Arlington High School Building Committee
Finance Subcommittee Meeting
Thursday, July 9, 2020
Conducted by Remote Participation
4:00pm – 5:00pm
Agenda

RE: Arlington High School
Consigli Job #2153
Early Bid Package 4
Owner Approval Letter No. 11 - EBP#4 Concrete (Phase 1)

RE: Arlington High School
Consigli Job #2153
Early Bid Package 4
Owner Approval Letter No. 12 – EBP#4 Structural Steel (Phase 1)

Change Order (CO)

A3.1 Fourth Floor RC Plan

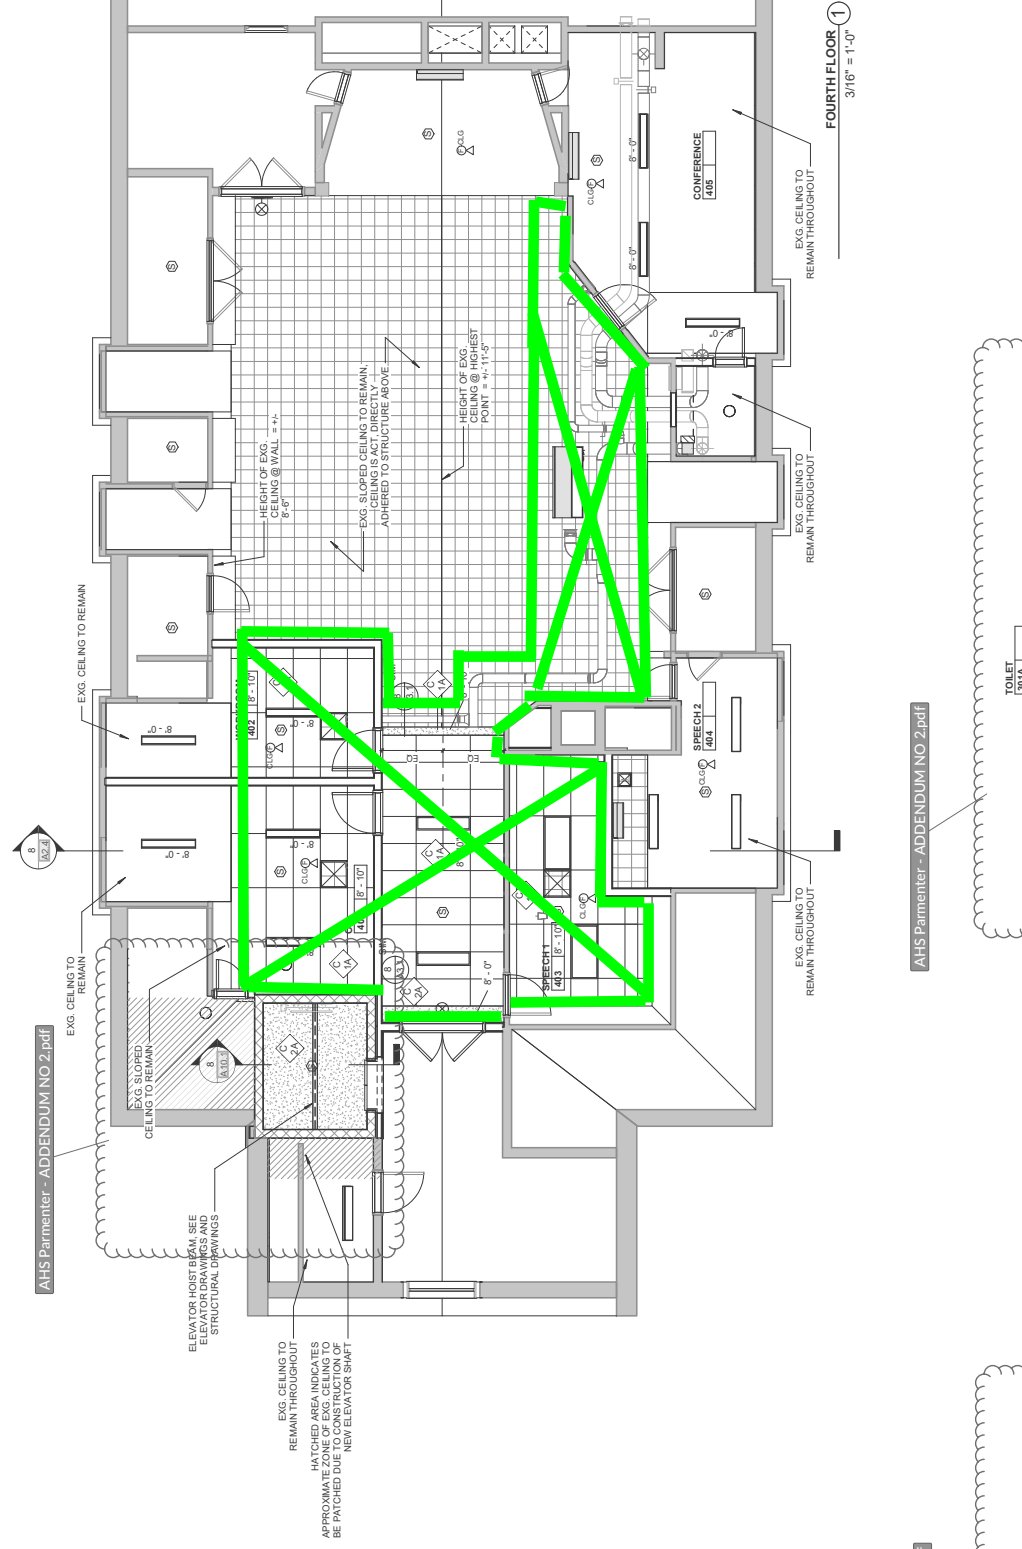
Change Event: Additional Labor Cost associated with demo of solid CMU Wall shown as GWB Partition

RFI #10

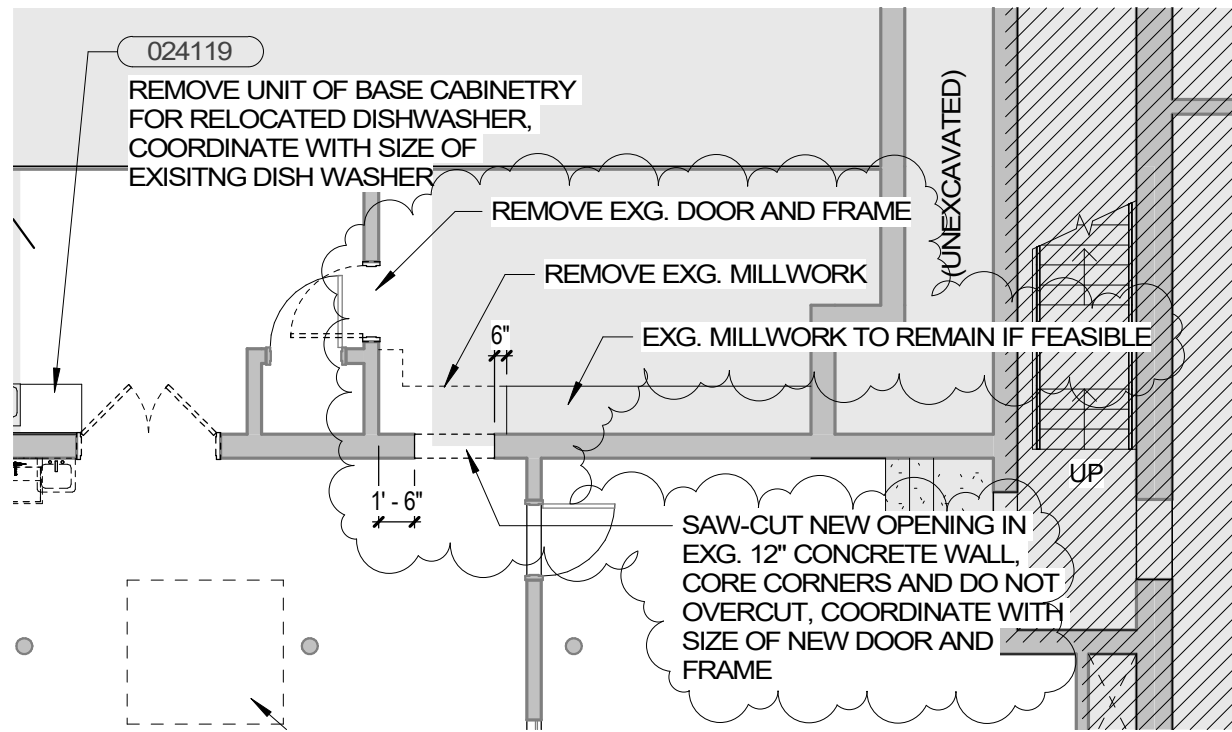
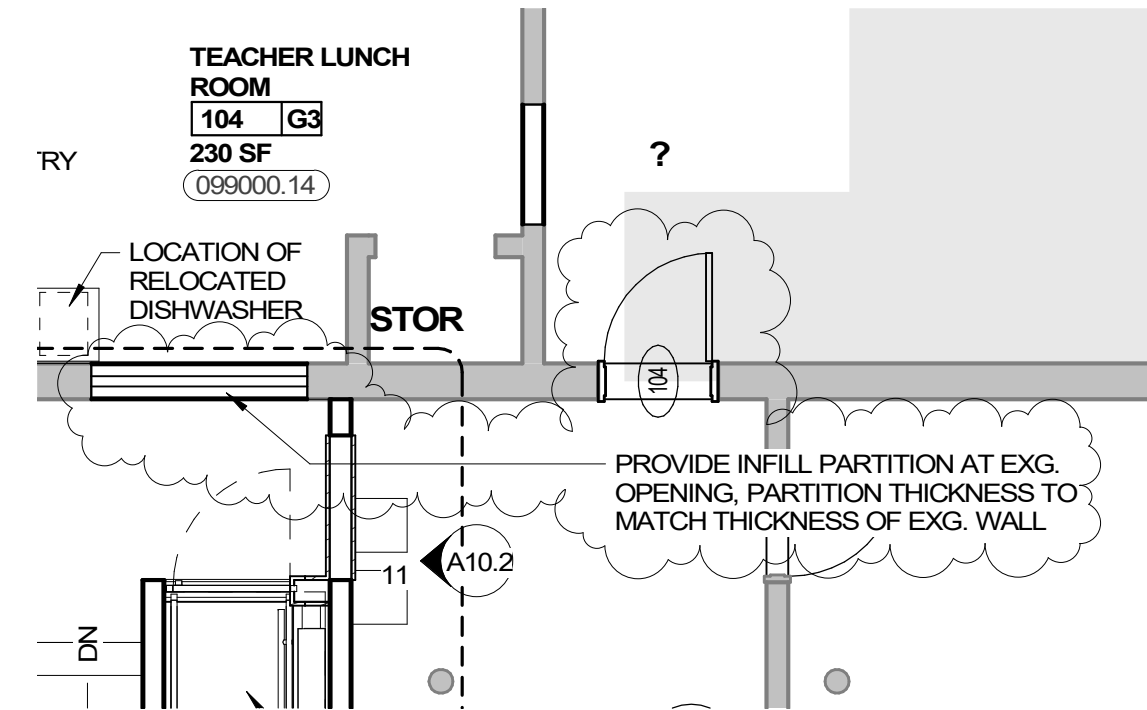
CR012 includes costs associated with relocating existing door 104 opening as indicated in RFI #010 and SKA-010. Per the RFI, there is a discrepancy between the contract drawings (A2.1) and the actual existing location of Door 104. If door 104 was to remain per CD's the new raised slab would block access into room 104 (Teachers Lunch Room).

- Sawcut/Demo Opening in Existing CIP Wall
- Remove adjacent Millwork
- Relocate existing electrical devices
- GWB infill at existing opening (painting excluded)

Official Response: Peter Rust (HMFH Architects) responded on Tuesday, April 28th, 2020 at 4:57PM EDT
